Dominion Energy Nuclear Connecticut, Inc.
5000 Dominion Boulevard, Glen Allen, VA 23060
DominionEnergy.com

May 3, 2018

DOMINION ENERGY NUCLEAR CONNECTICUT, INC.
MILLSTONE POWER STATION UNIT 3
LICENSE AMENDMENT REQUEST REGARDING PROPOSED TECHNICAL
SPECIFICATIONS CHANGES FOR SPENT FUEL STORAGE AND NEW FUEL STORAGE

Figure 3.9-1 Region 1 Fuel Storage Loading Schematic

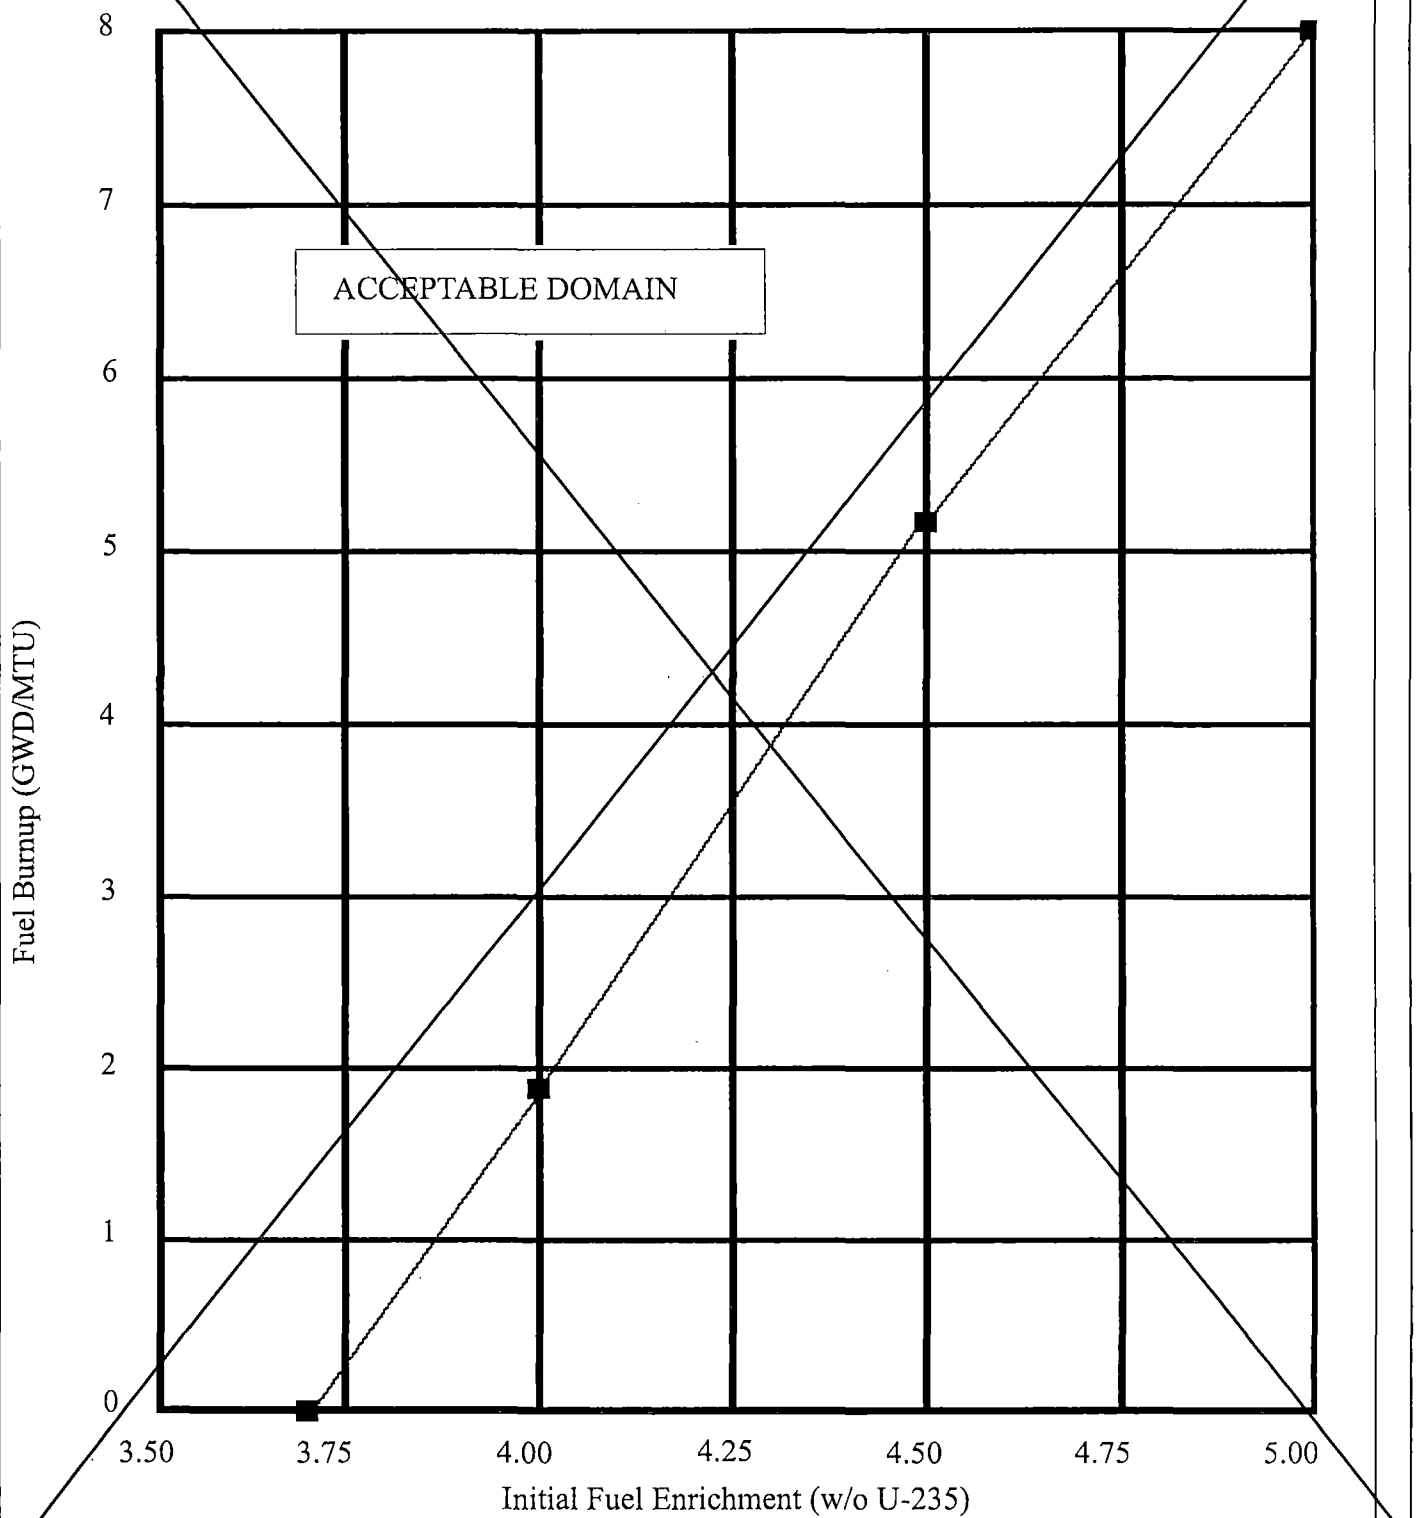
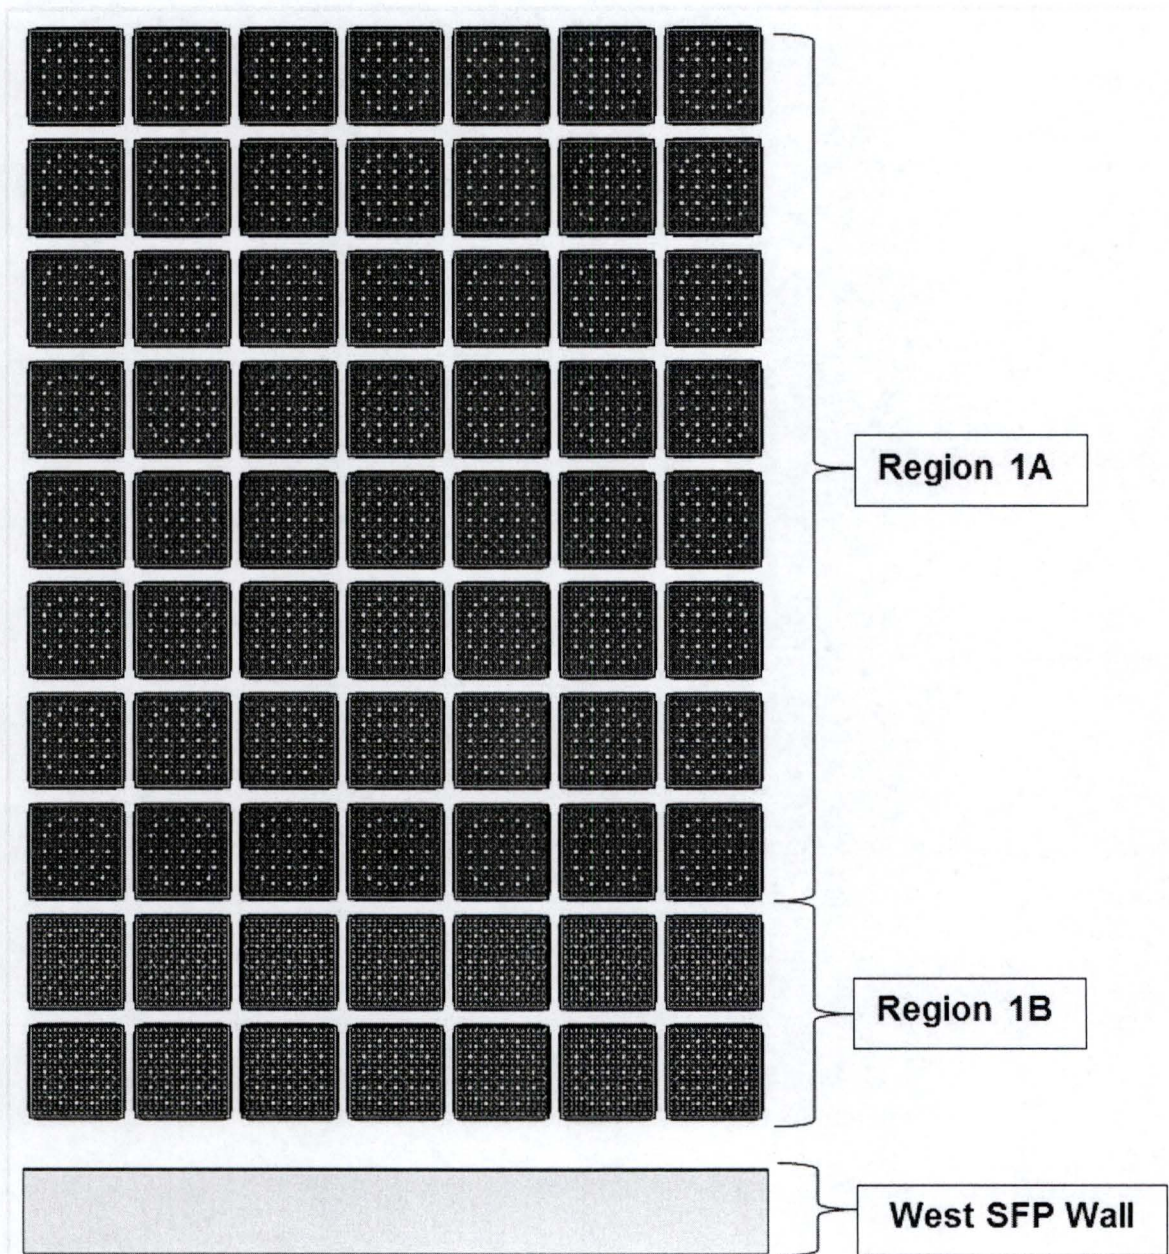
TS Figure 3.9-1

TS Figure 3.9-1 is replaced. The new figure shows the bounding Region 1 fuel storage loading schematic, including which storage locations are designated as Region 1A and 1B.

The Region 1 Fuel Storage Loading Schematic (Figure 3.9-1) designates each storage location as either Region 1A or Region 1B.

- (2) Region 1B – Fuel assemblies with an initial enrichment less than or equal to 5.0 w/o U-235 shall be stored per the Fuel Storage Loading Schematic shown in Figure 3.9-1 (the two rows against the spent fuel pool west wall are designated Region 1B).

FIGURE 3.9-2 Minimum Fuel Assembly Burnup versus Initial Enrichment for Region 2
Storage Configuration
(Fuel Assemblies without Rod Cluster Control Assemblies)

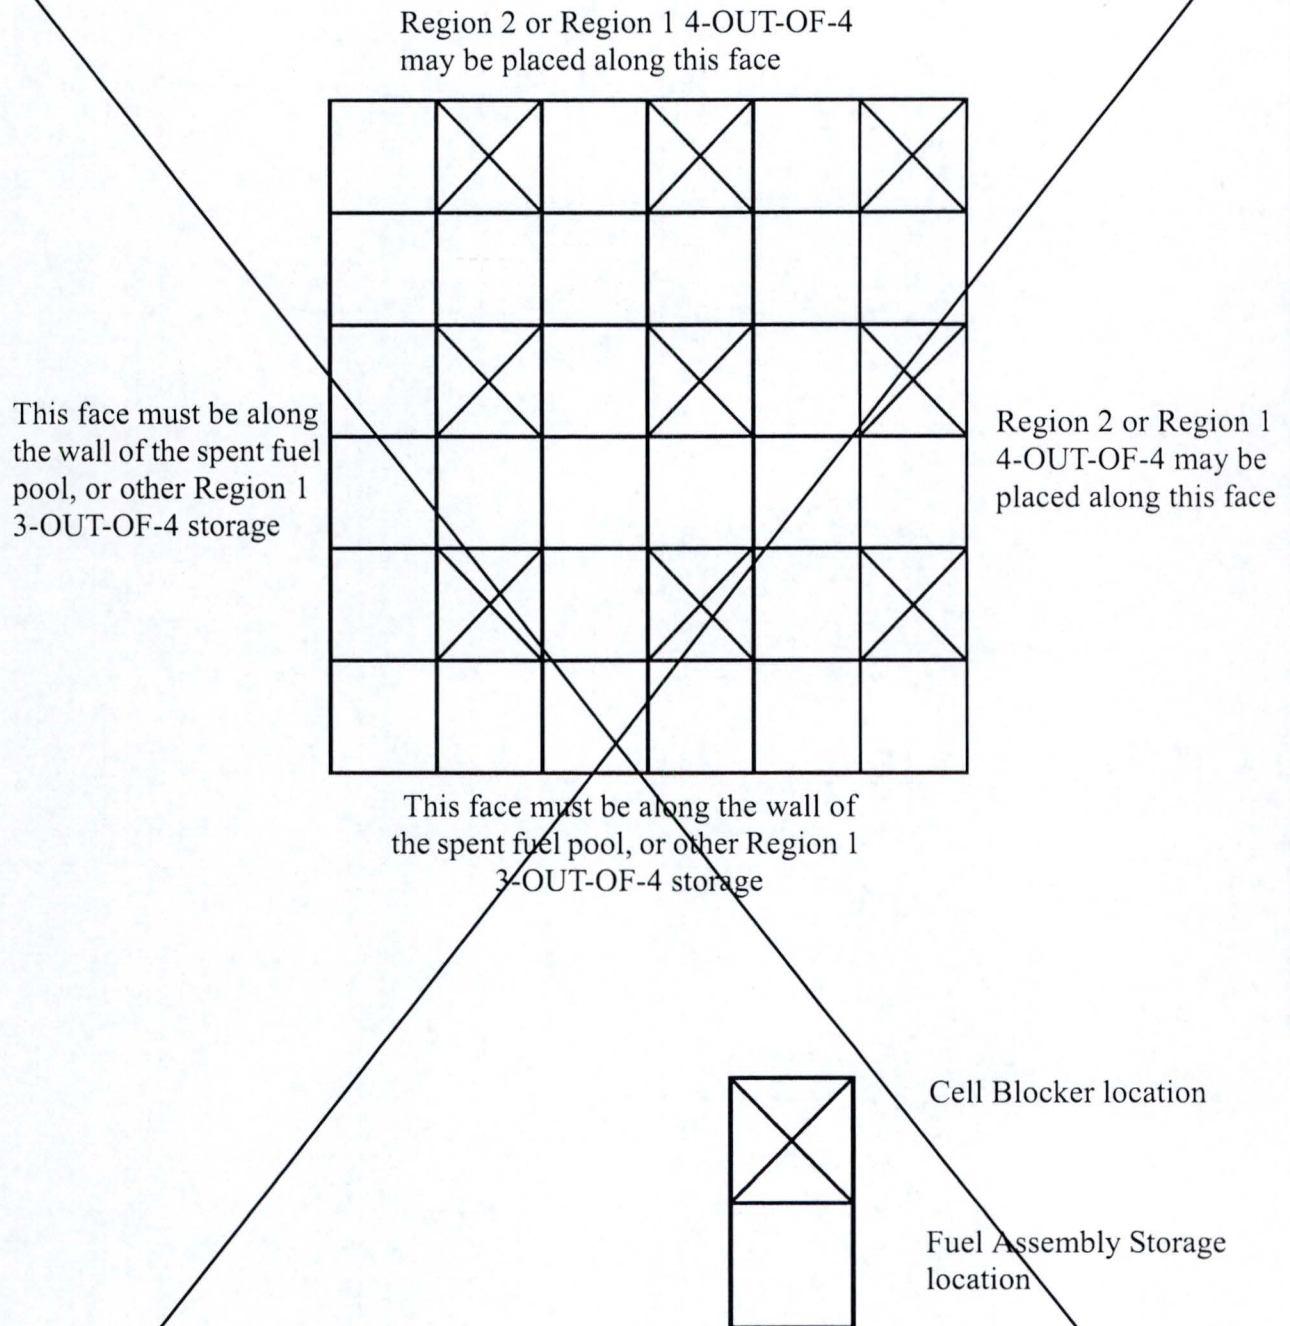
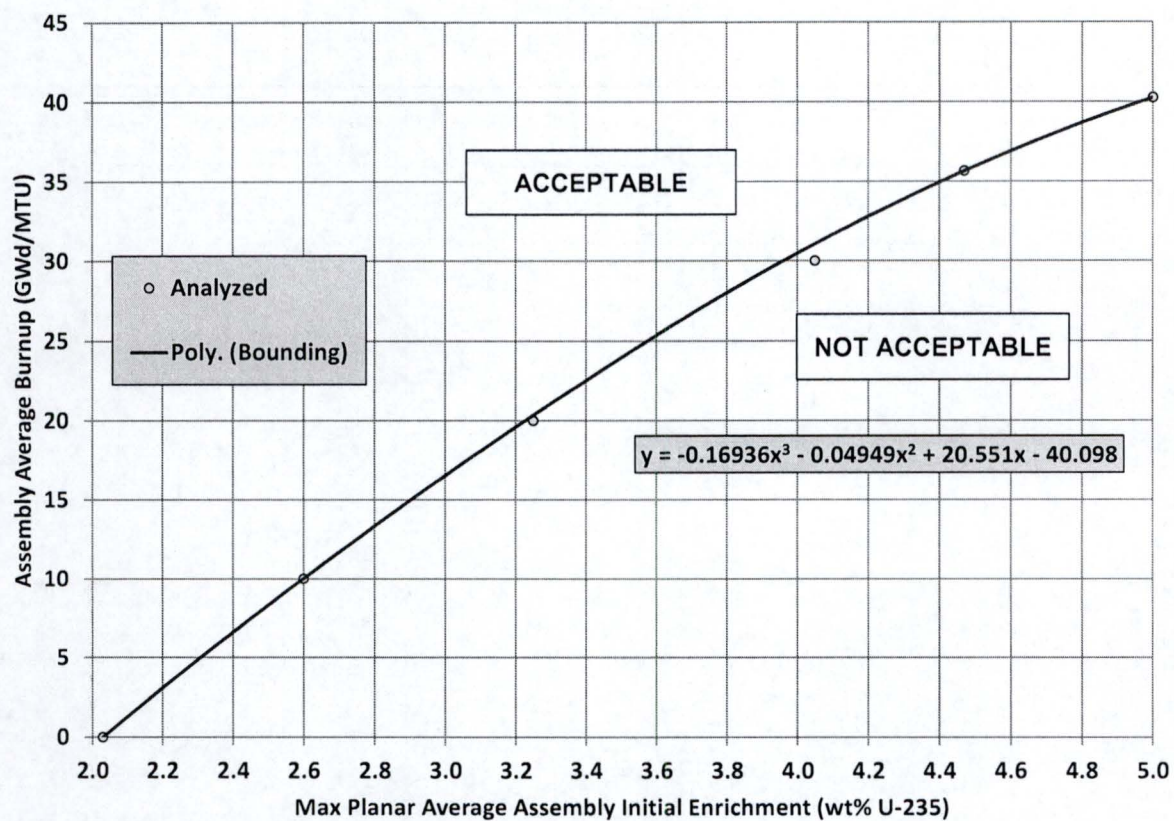
TS Figure 3.9-2

TS Figure 3.9-2 is replaced. This new figure shows the minimum required fuel assembly burnup as a function of initial enrichment to permit storage in Region 2 (for assemblies that do not contain a RCCA).

Fuel assemblies may be stored in Region 2 if they are in the acceptable burnup domain of the initial enrichment/burnup curve in Figure 3.9-2, or contain a RCCA (no burnup restriction).

- Region 2, a nominal 9.017 inch center to center distance, credits a fixed neutron absorber (BORAL) within the rack and either fuel burnup as shown in Figure 3.9-2 or takes credit for containing a Rod Cluster Control Assembly.

FIGURE 3.9-3 Minimum Fuel Assembly Burnup and Decay Time versus Initial Enrichment for Region 3 Storage Configuration

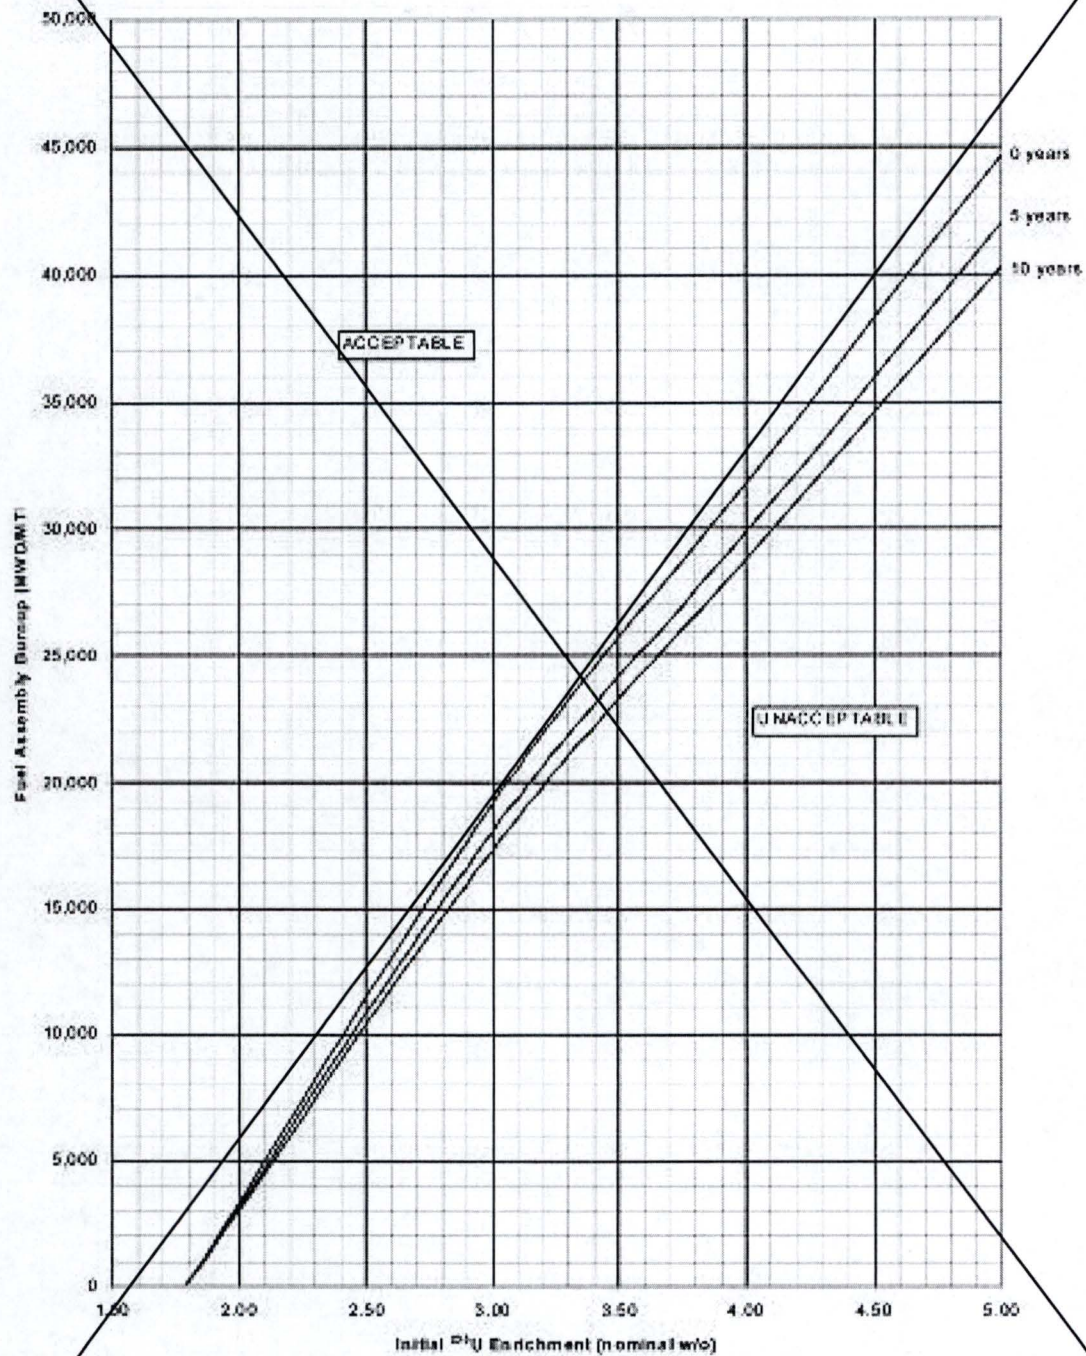
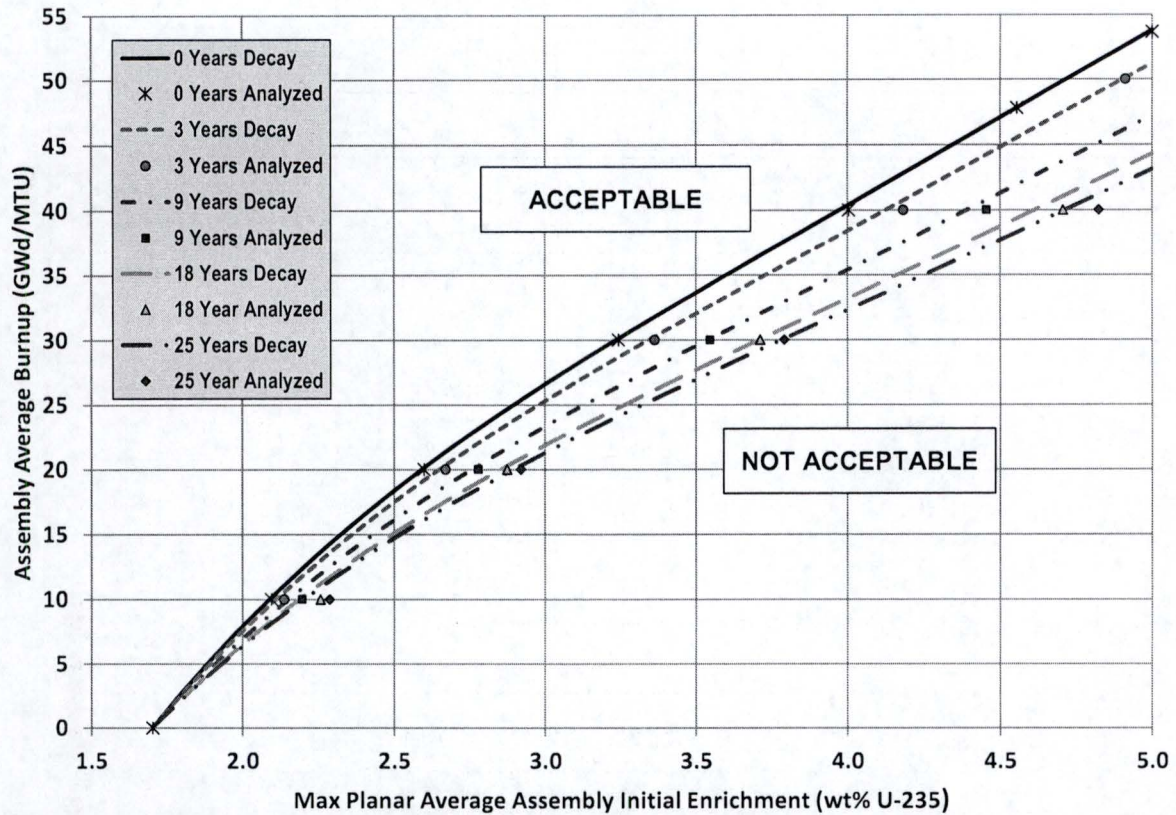
TS Figure 3.9-3

TS Figure 3.9-3 is replaced. This new figure shows the minimum required fuel assembly burnup and decay time as a function of initial enrichment to permit storage in Region 3.

Fuel assemblies may be stored in Region 3 if they are in the acceptable burnup/decay time domain of the initial enrichment/burnup/decay time curve in Figure 3.9-3.

- Region 3, a nominal 10.35 inch center to center distance, credits fuel burnup and decay time as shown in Figure 3.9-3. These racks contain Boraflex which is not credited.

Figure 3.9-4 Minimum Fuel Assembly Burnup and Decay Time Versus Nominal Initial Enrichment for Region 3 Storage Configuration for Assemblies from Pre-Uprate (3411 Mwt) Cores

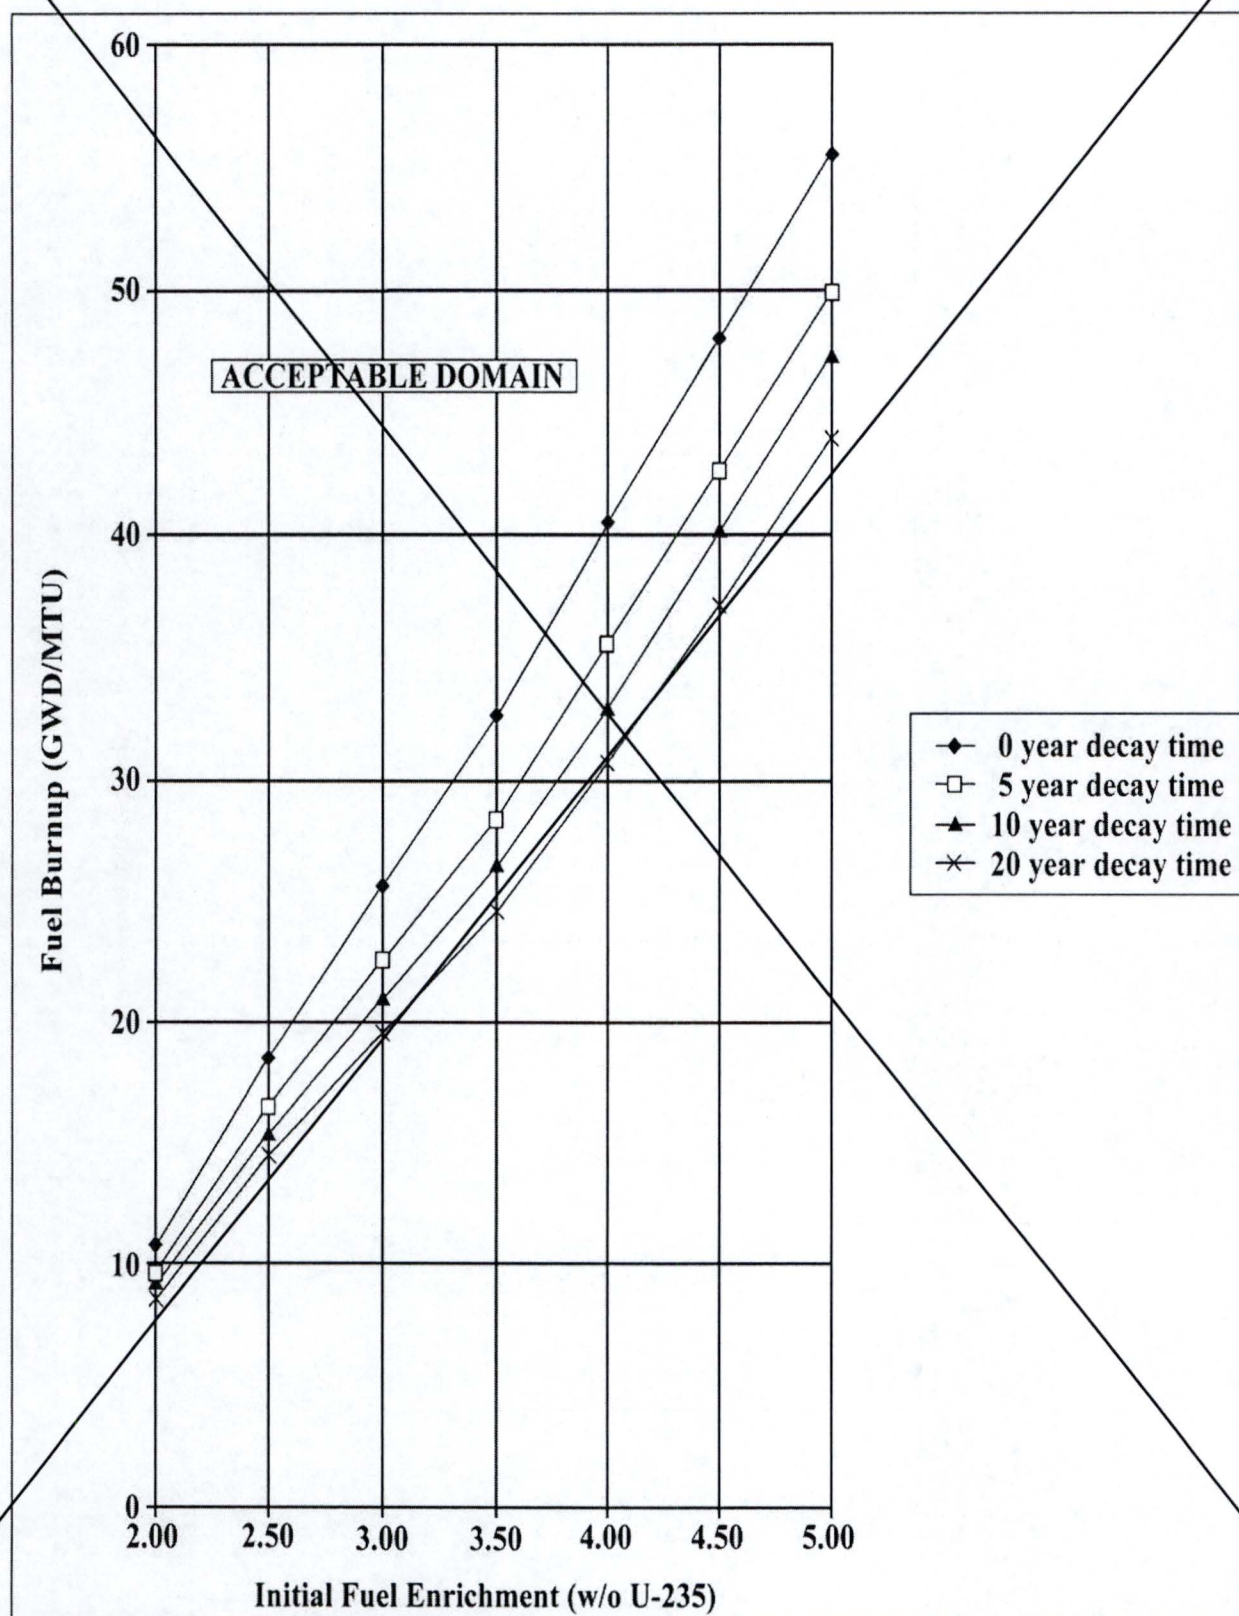
TS Figure 3.9.4

TS Figure 3.9-4 is deleted.
